# BEAC PUBLIC HEARING

## LOCAL ADOPTION OF THE LATEST CALIFORNIA BUILDING STANDARDS CODE AND UNIFORM HOUSING CODE

**AUGUST 19, 2019**

**SUSTAINABLE  
LONG BEACH**

FIGURE 1809.3  
STEPPED FOOTING

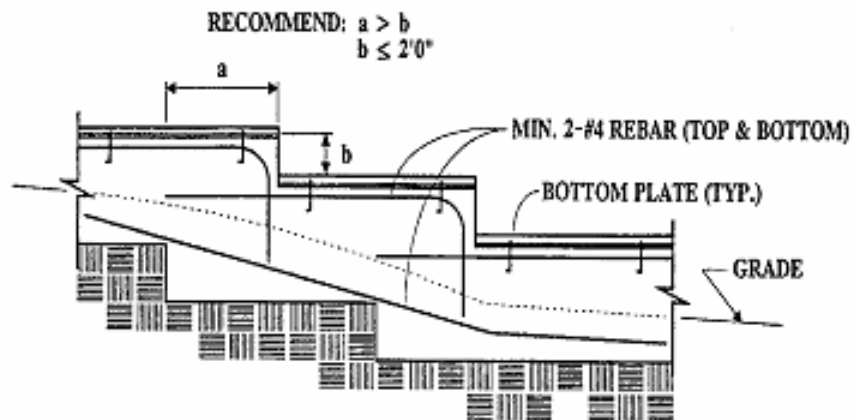
1809.3 Stepped footings. The top surface of footings shall be level. The bottom surface of footings shall be permitted to have a slope not exceeding one unit vertical in 10 units horizontal (10-percent slope). Footings shall be stepped where it is necessary to change the elevation of the top surface of the footing or where the surface of the ground slopes more than one unit vertical in 10 units horizontal (10-percent slope).

For structures assigned to Seismic Design Category D, E or F, the stepping requirement shall also apply to the top surface of grade beams supporting walls. Footings shall be reinforced with four 1/2-inch diameter (12.7 mm) deformed reinforcing bars. Two bars shall be placed at the top and bottom of the footings as shown in Figure 1809.3.

**FIGURE 2308.6.5.1  
ALTERNATE BRACED WALL PANEL (ABW)**

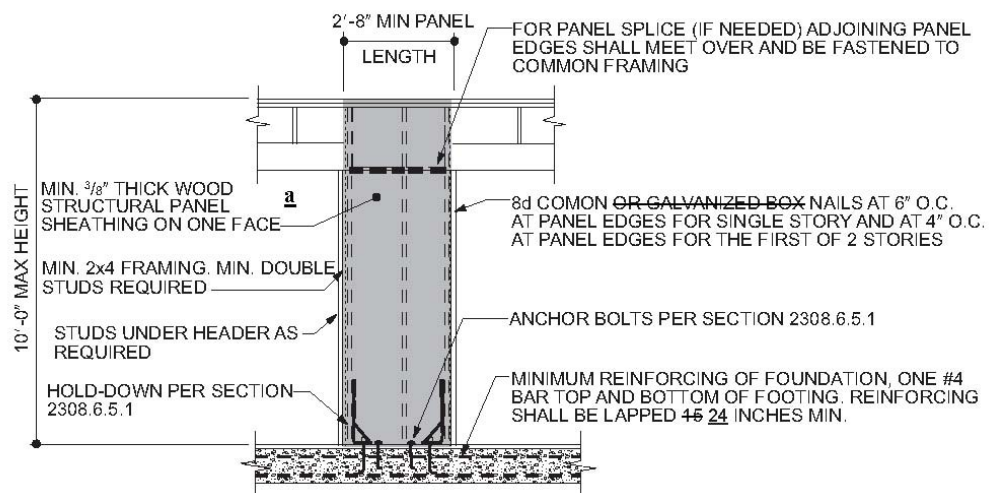
18.40.280 – Amend CBC Section 2308.6.5.1 and Figure 2308.6.5.1—Alternate braced wall.

Section 2308.6.5.1 and Figure 2308.6.5.1 of the ~~2016~~2019 Edition of the California Building Code ~~is~~are amended to read as follows:

2308.6.5.1 Alternate braced wall (ABW). An ABW shall be constructed in accordance with this section and Figure 2308.6.5.1. In one-story buildings, each panel shall have a length of not less than 2 feet 8 inches (813 mm) and a height of not more than 10 feet (3048 mm). Each panel shall be sheathed on one face with 3/8-inch (3.2 mm) minimum-thickness wood structural panel sheathing nailed with 8d common or galvanized box nails in accordance with Table 2304.10.1 and blocked at wood structural panel edges. For structures assigned to Seismic Design Category D or E, each panel shall be sheathed on one face with 15/32-inch-minimum-thickness (11.9 mm) wood structural panel sheathing nailed with 8d common nails spaced 3 inches on panel edges, 3 inches at intermediate supports. Two anchor bolts installed in accordance with Section 2308.3.1 shall be provided in each panel. Anchor bolts shall be placed at each panel outside quarter points. Each panel end stud shall have a hold-down device fastened to the foundation, capable of providing an approved uplift capacity of not less than 1,800 pounds (8006 N). The hold-down device shall be installed in accordance with the manufacturer's recommendations. The ABW shall be supported directly on a foundation or on floor framing supported directly on a foundation that is continuous across the entire length of the braced wall line. This foundation shall be reinforced with not less than one No. 4 bar top and bottom. Where the continuous foundation is required to have a depth greater than 12 inches (305 mm), a minimum 12-inch by 12-inch (305 mm by 305 mm) continuous footing is permitted at door openings in the braced wall line. This continuous footing shall be reinforced with not less than one No. 4 bar top and bottom. This reinforcement shall be lapped 24 inches (610 mm) with the reinforcement required in the continuous foundation located directly under the braced wall line.

Where the ABW is installed at the first story of two-story buildings, the wood structural panel sheathing shall be provided on both faces, three anchor bolts shall be placed at one-quarter points and tie-down device uplift capacity shall be not less than 3,000 pounds (13 344 N).
